REQUEST FOR INFORMATION **DATE:** July 20, 2017 **NO.:** RFI-591

Project Name: 15051-Webster University Interdisciplinary Science Building Project No.: 15051

Subject: 1st Floor EAB Connection Confirmation

EAB
CONNECTOR

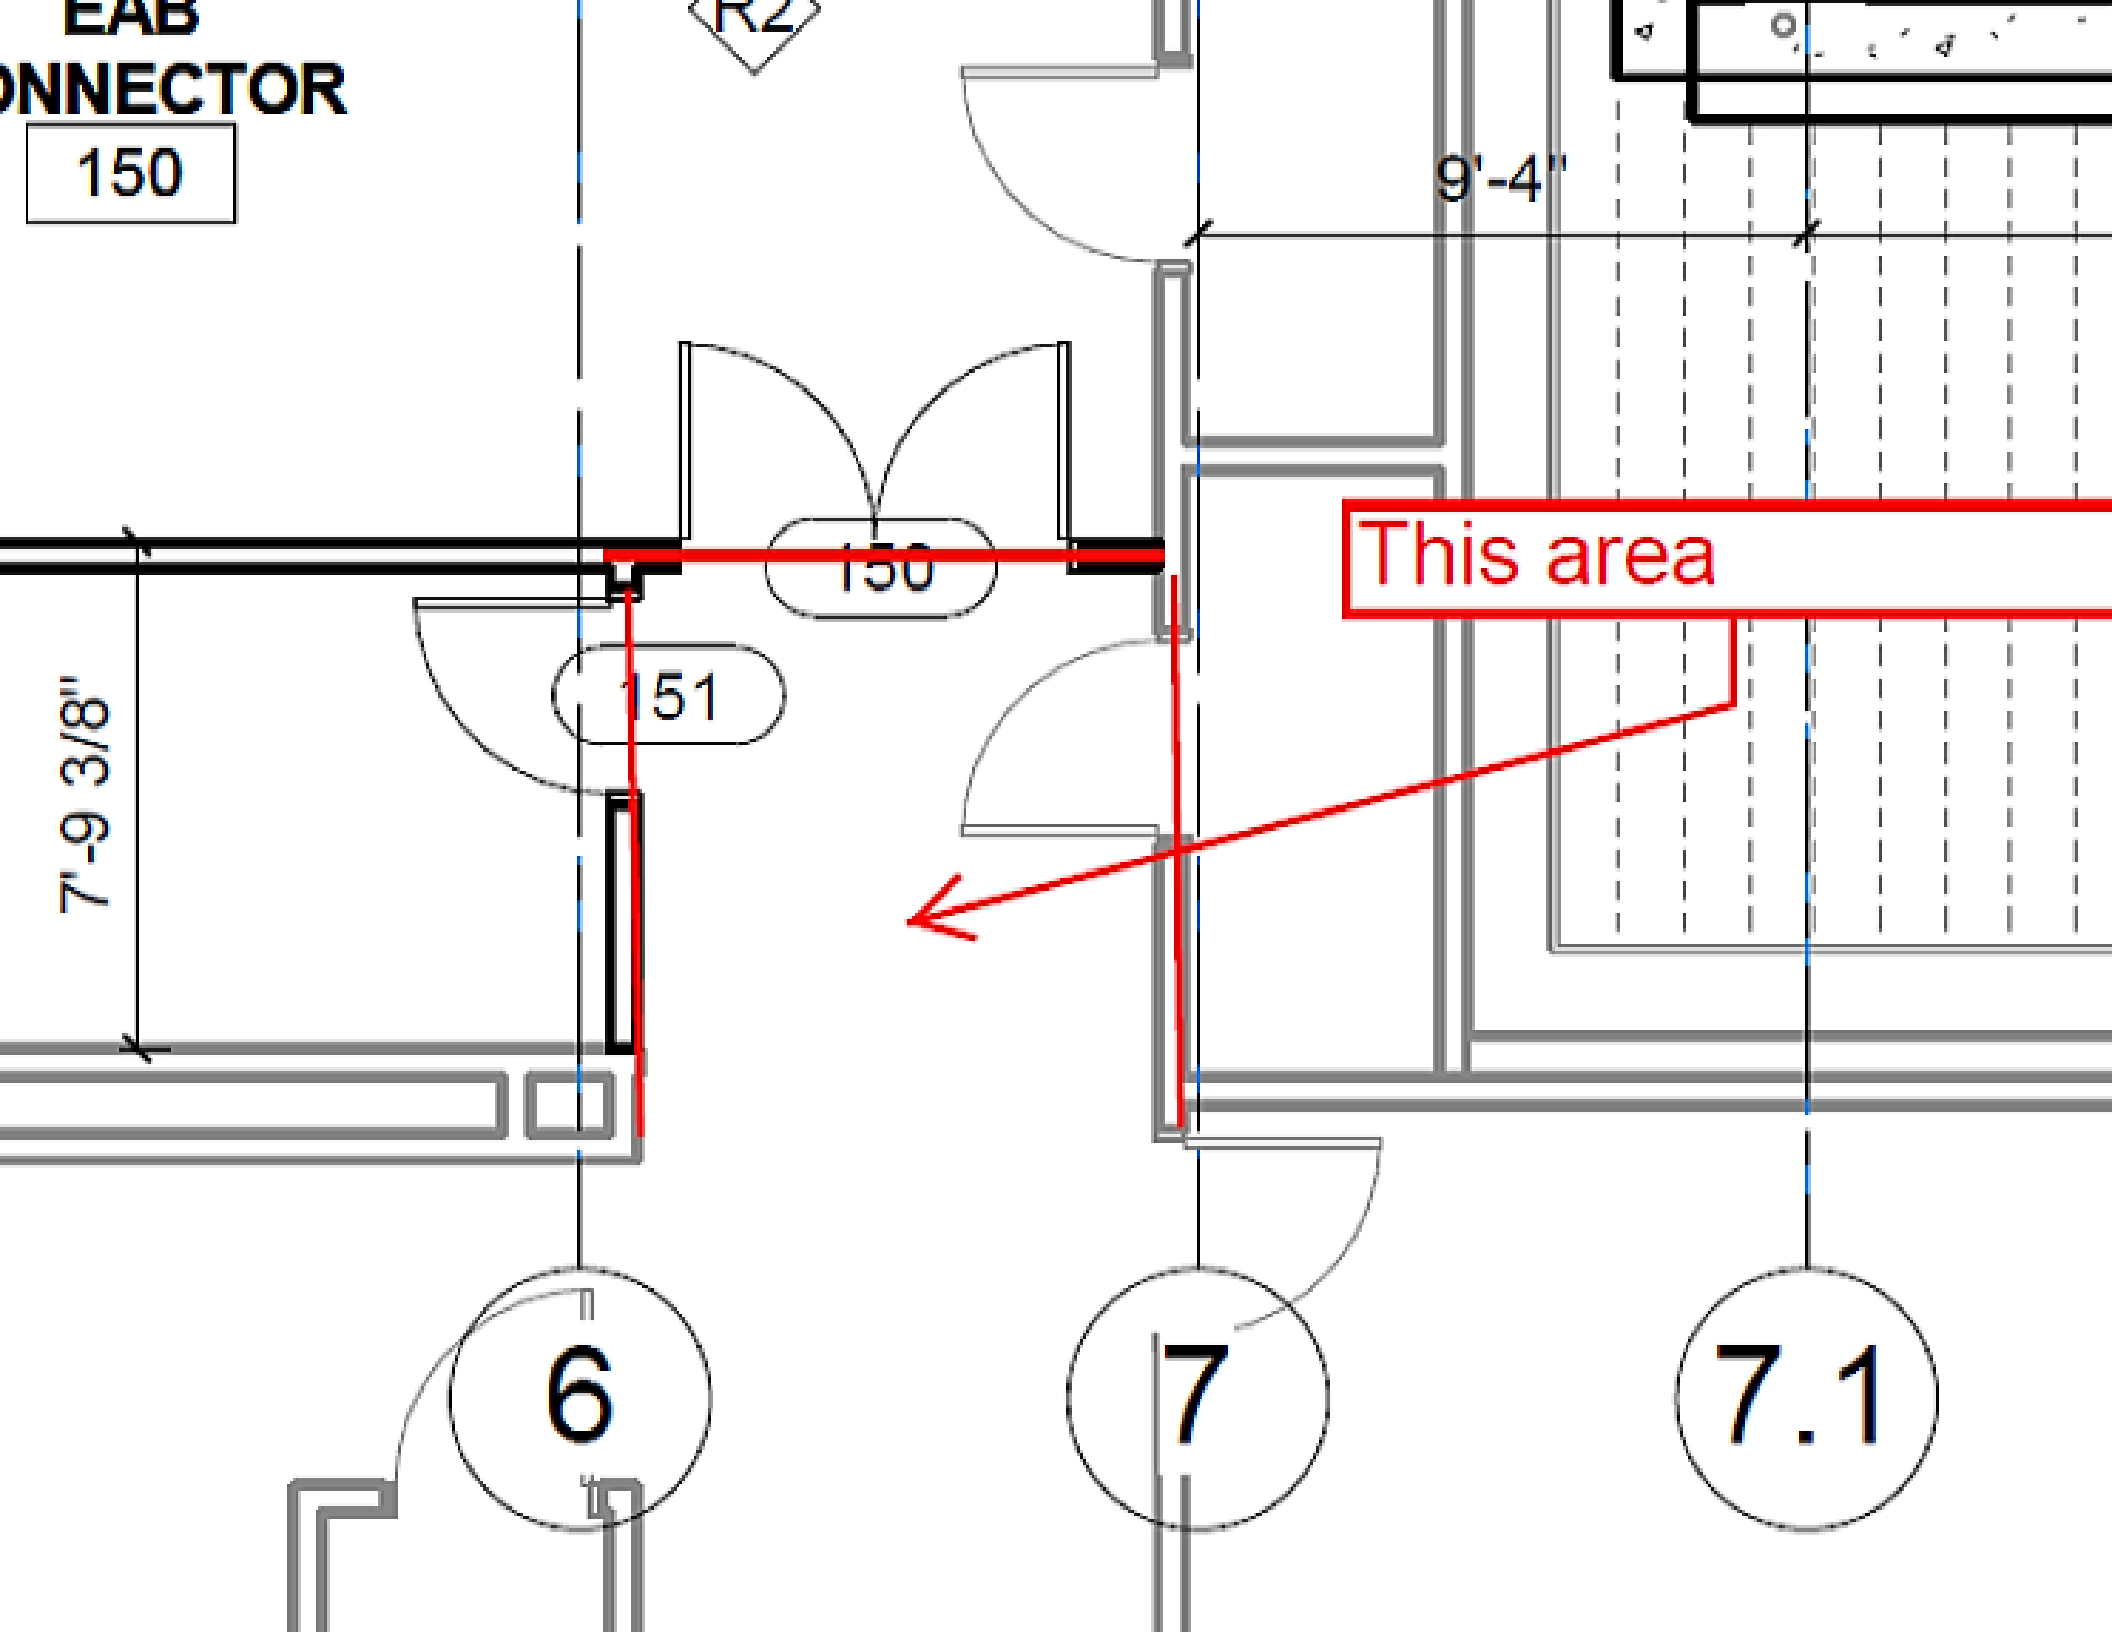
Please confirm the following construction at the 1st floor EAB connector:

1. Ceiling will be approx. 8'6" (existing ceiling is 9'6") due to existing ductwork height. **OK.**
2. The two RQ fixtures will be eliminated because there is only 7'6" in length and fixtures require 8'. An additional RH fixture will be added for proper light levels (see attached email). **OK.**
3. The new and existing gypsum partitions in this area will need to be double layered to allow for the base to be flush with the gyp. **OK.**
4. New wood base and casing to match existing will need to be applied at new and existing doorways within the existing EAB corridor extension area. **OK.**

NOTE, THAT THE FINISH (STAIN COLOR & WOOD GRAIN DIRECTION) FOR DOORS 150 & 151 SHOULD MATCH THE EXISTING EAB DOORS.

CURRENTLY, DOOR 150 HAS WRONG STAIN COLOR. AND DOOR 151 HAS WRONG GRAIN DIRECTION.

STAIN COLOR
TO MATCH
EXISTING EAB
DOORS.
